**Subject:** Submittal of Replacement Pages to Update the NAC-UMS<sup>®</sup> FSAR from Revision 4 to Revision 5 (Docket No. 72-1015)

**10 CFR 72.48 Evaluation Summary Report**

**NAC-UMS<sup>®</sup> Universal Storage System  
(Docket No. 72-1015)**

**98 TOP ASSEMBLY**  
WEIGHT: 23#  
SHOWN WITH ALUMINUM WPER, ITEM 4

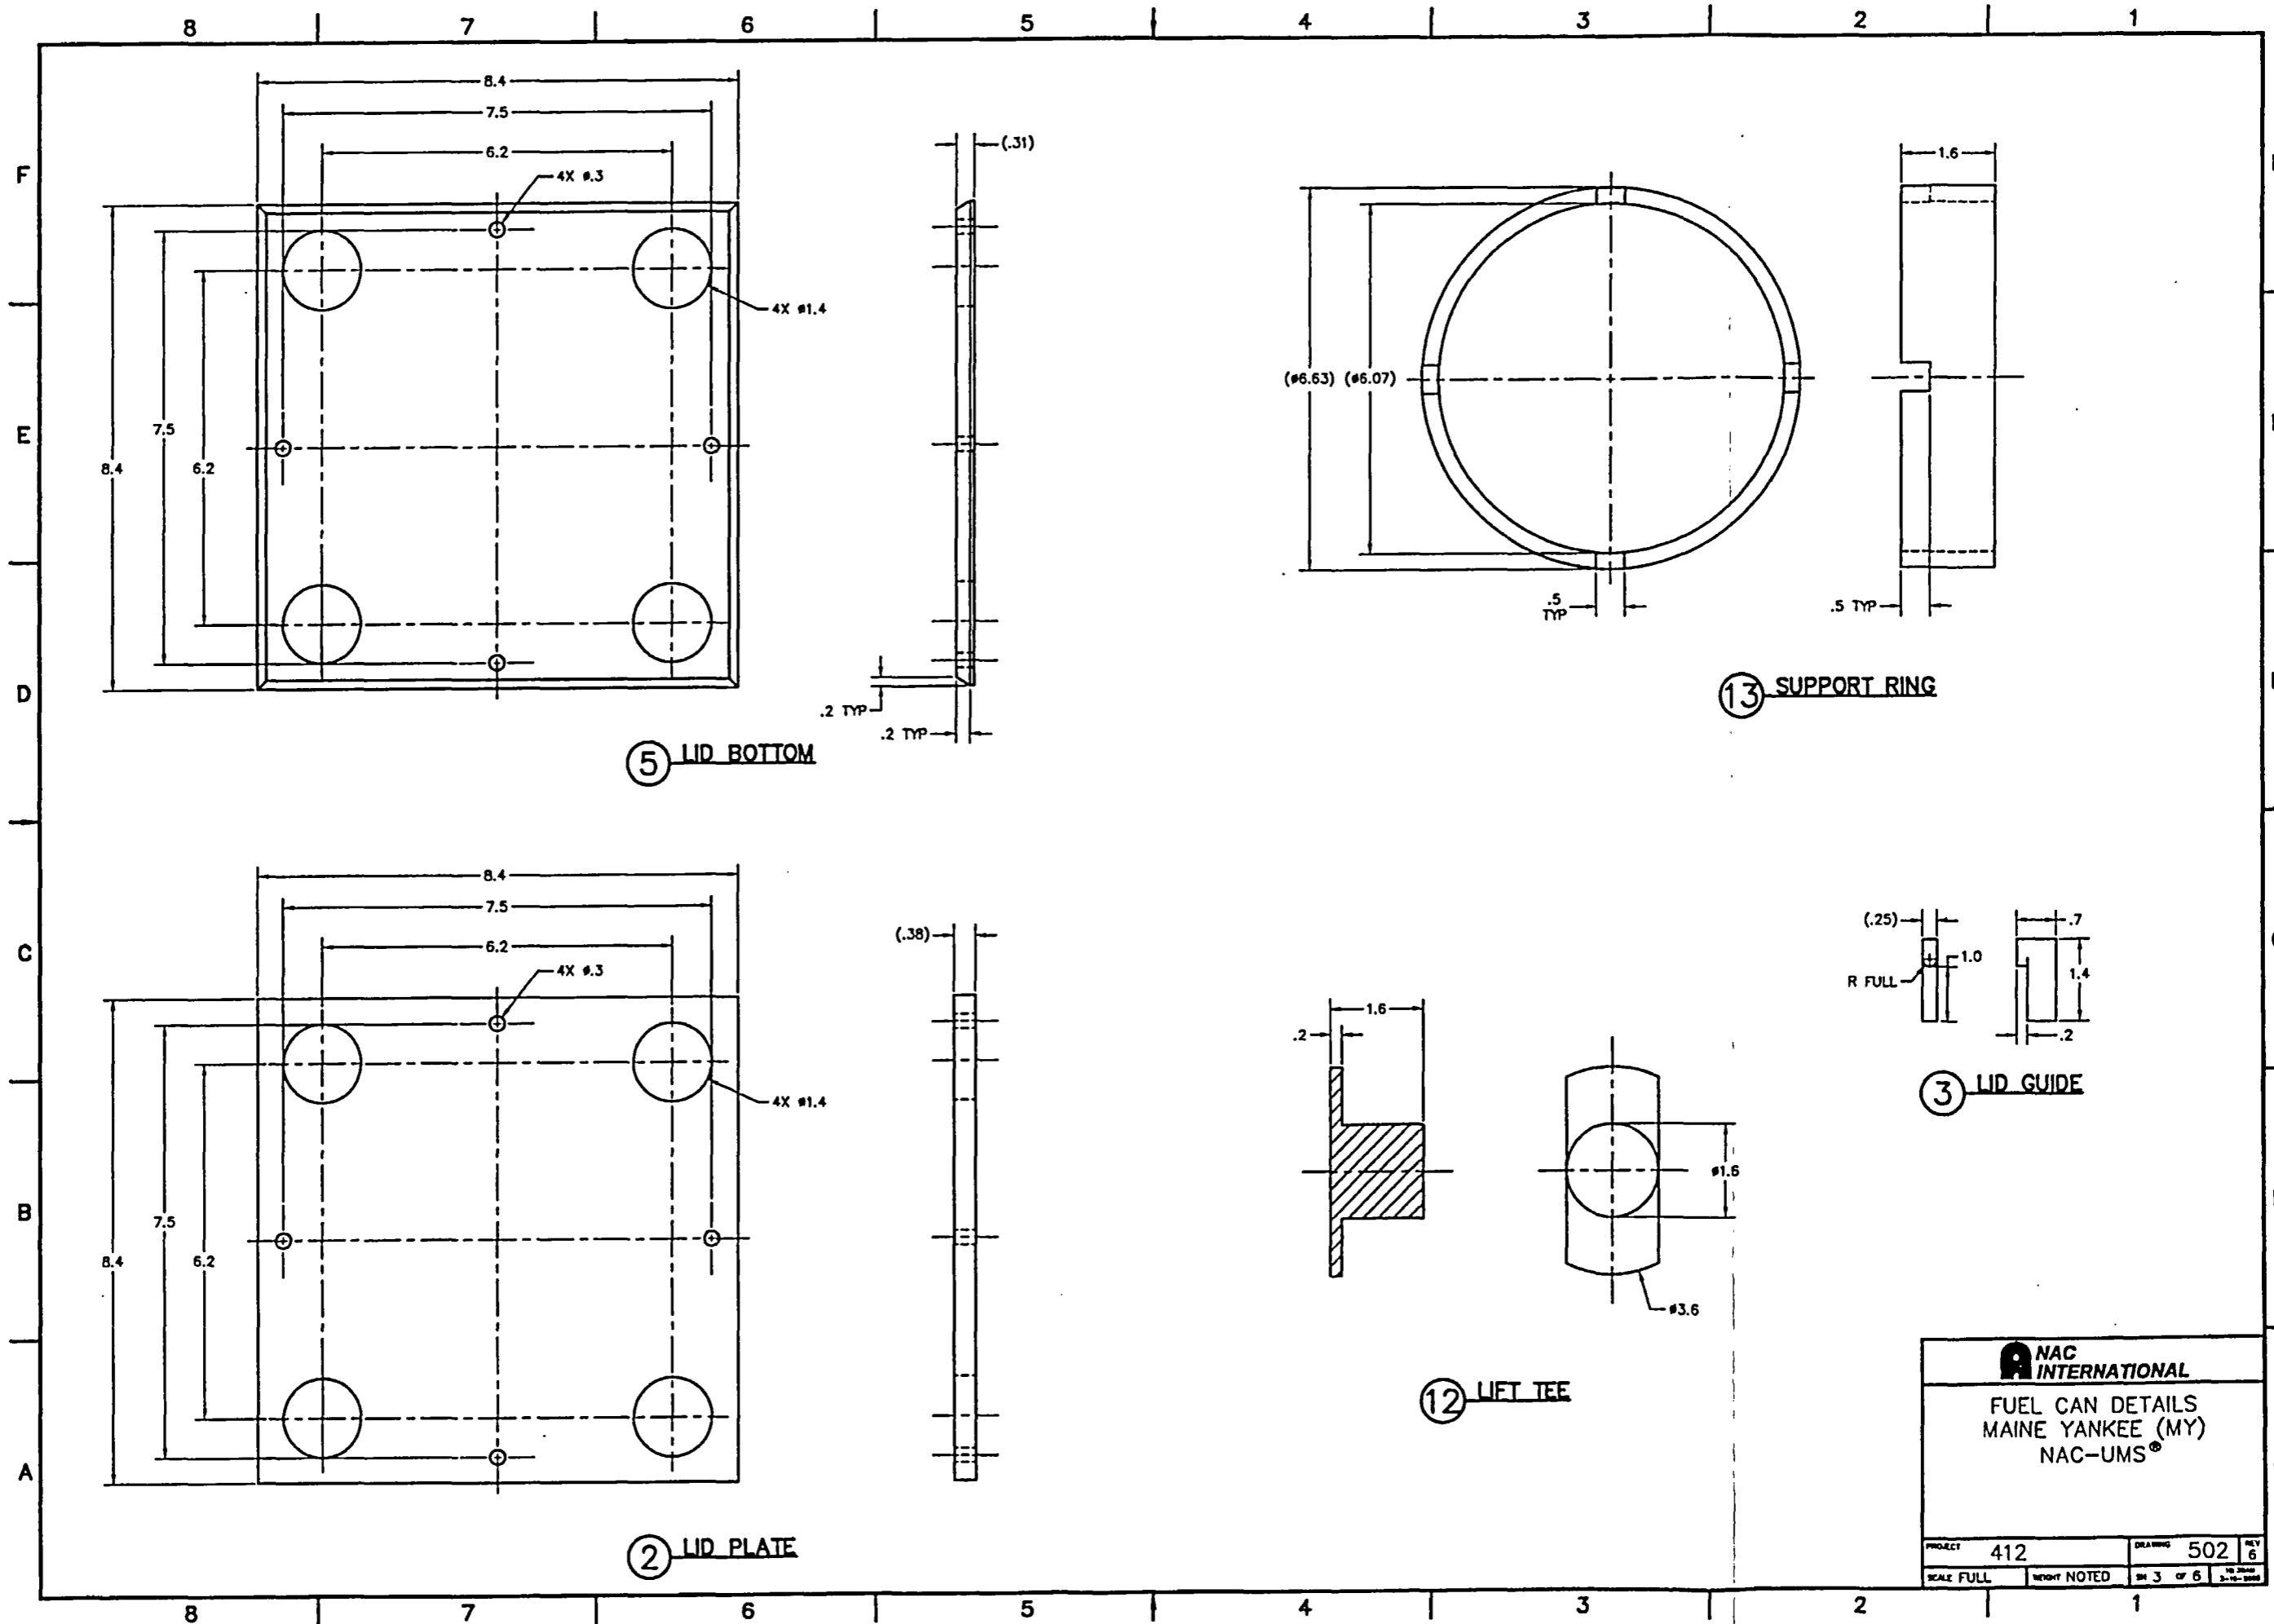
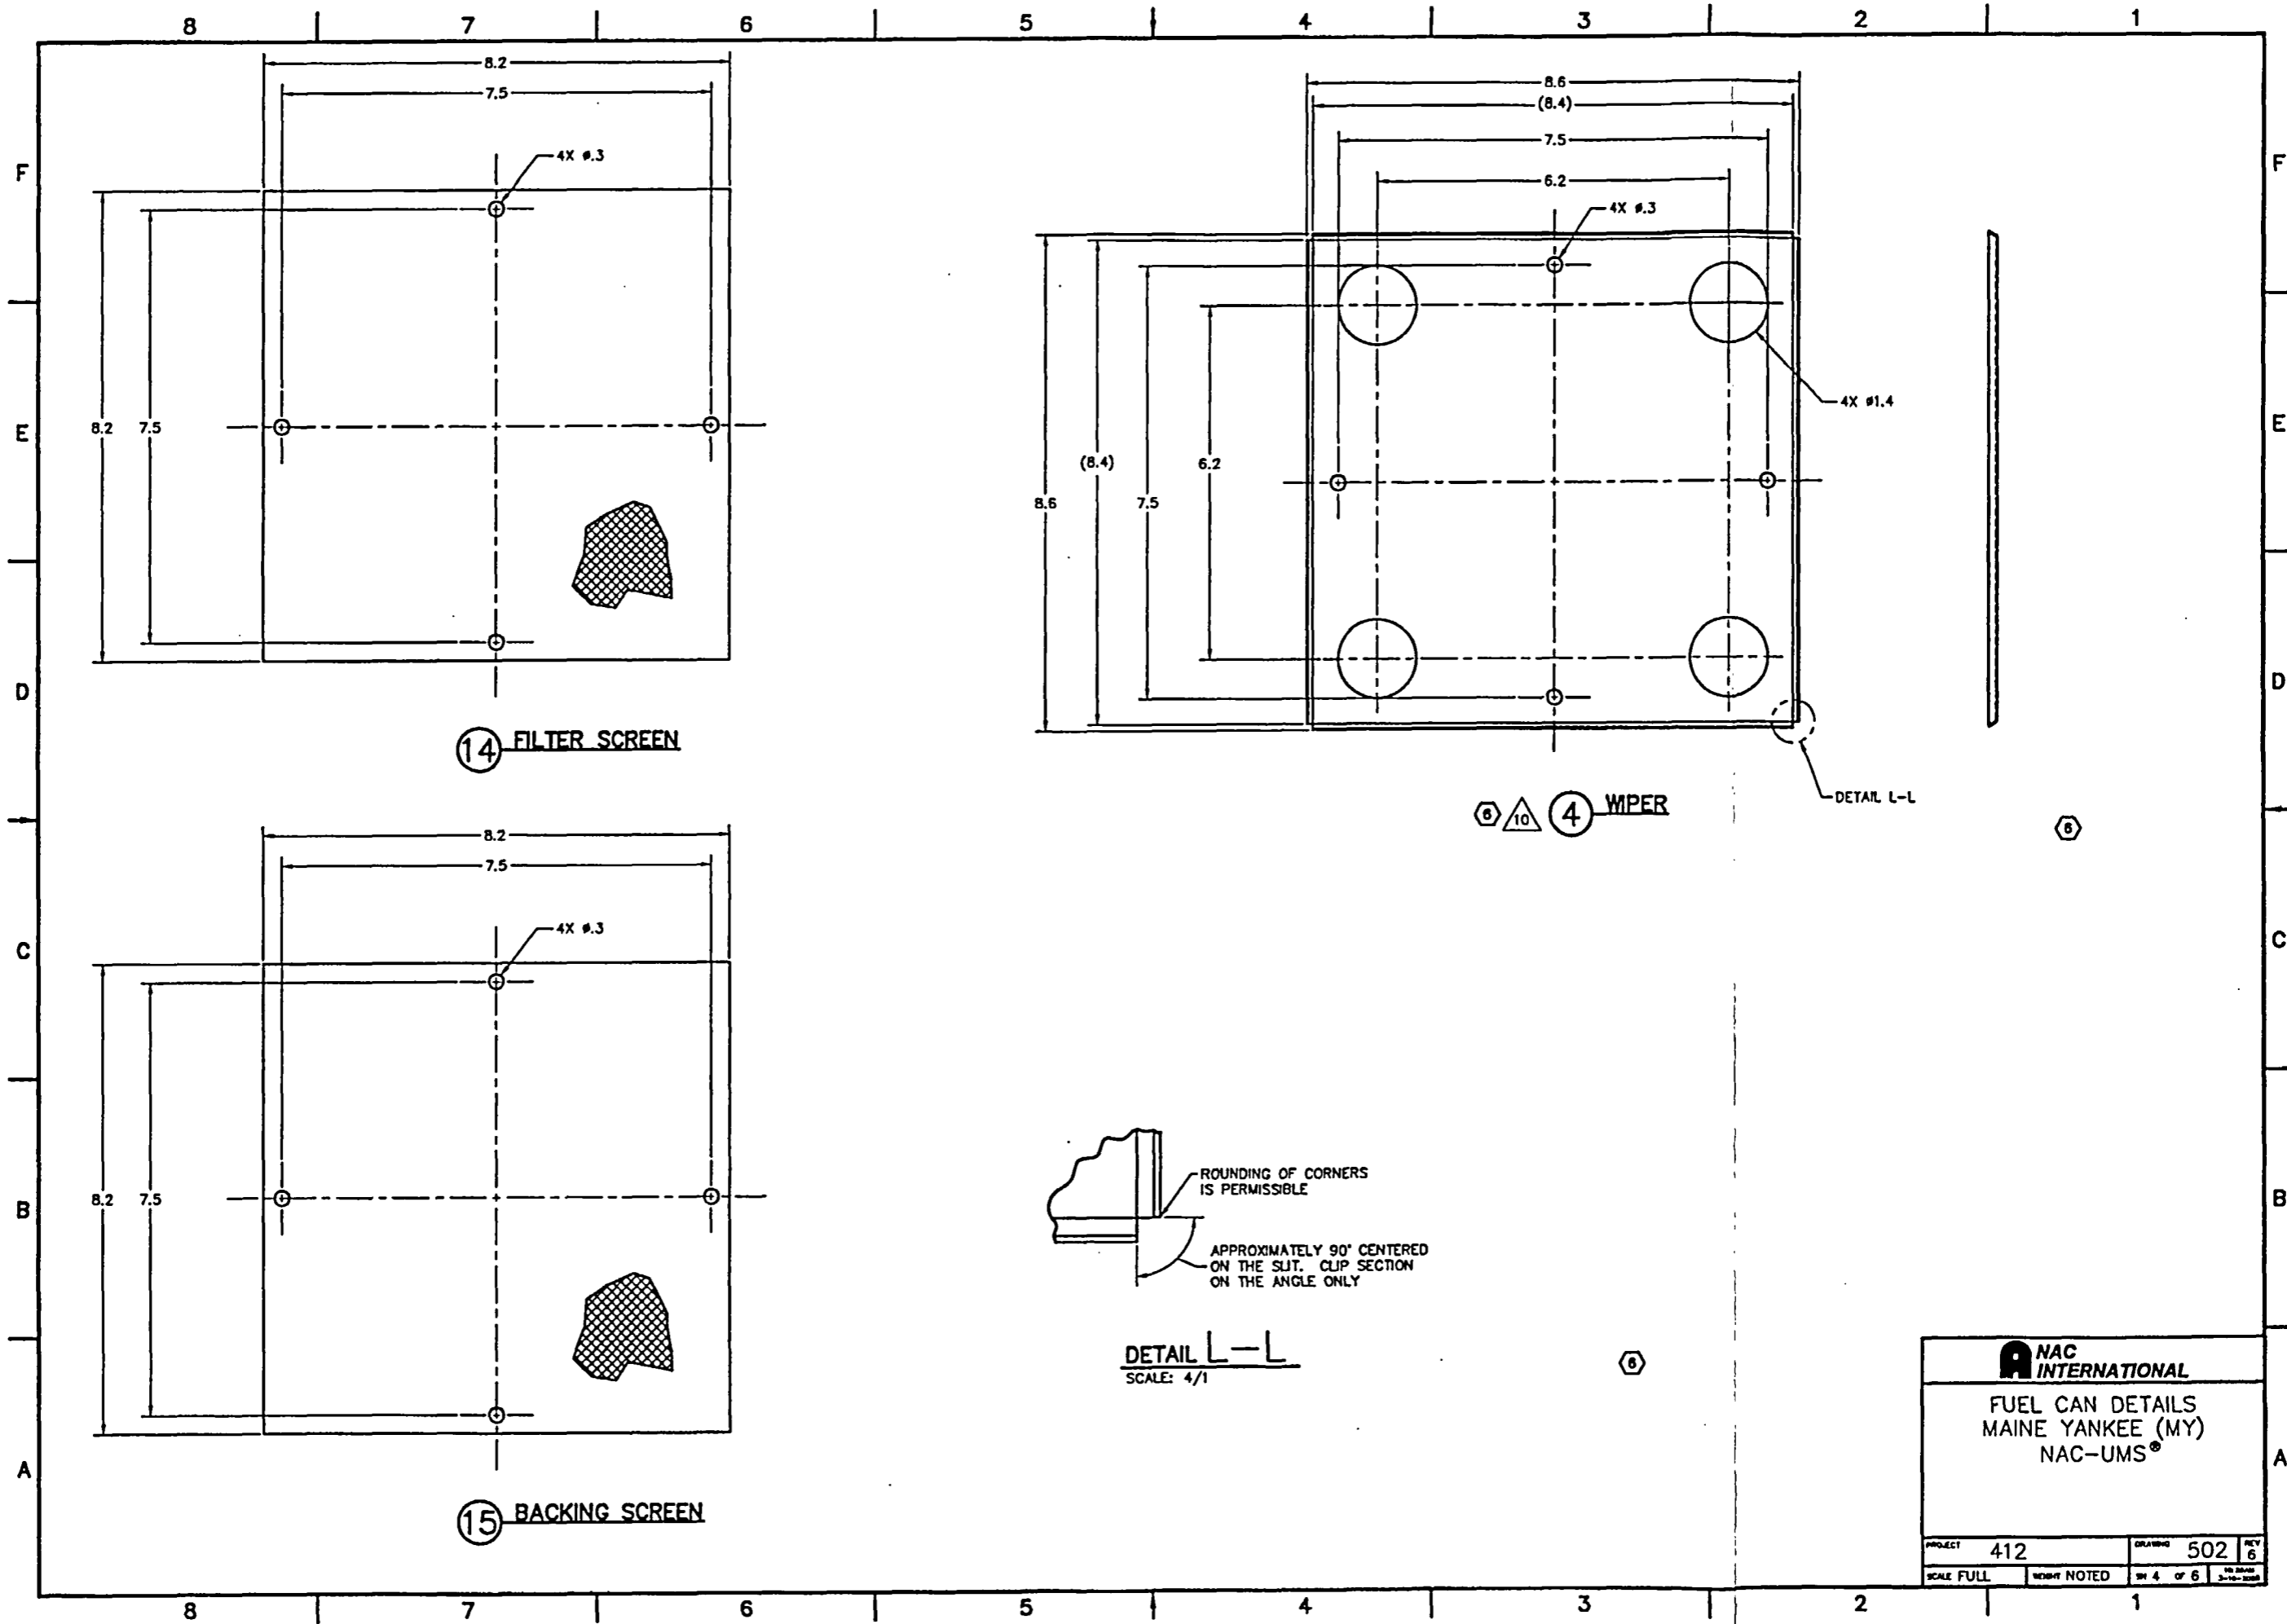
1. Added Delta Note 10 to Item 4, Wiper, "Minor edge surface and/or dimensional deviations are acceptable for Item 4, Wiper."
2. Deleted Detail B-B and callout on Sht 4 of 6, Zone A3 & D1.

The wiper is used to ensure that particles from damaged fuel assemblies stay inside the damaged fuel can. The surface finish and the exact profile/shape of the edge are not critical, so long as the wiper fills the gap between the damaged fuel can and the damaged fuel can lid to block that escape path. These changes have no impact on the performance of each component and/or the overall system functionality. With this DCR(L), the drawing will bound all the final as-built conditions noted in the site documentation packages for the Maine Yankee project.
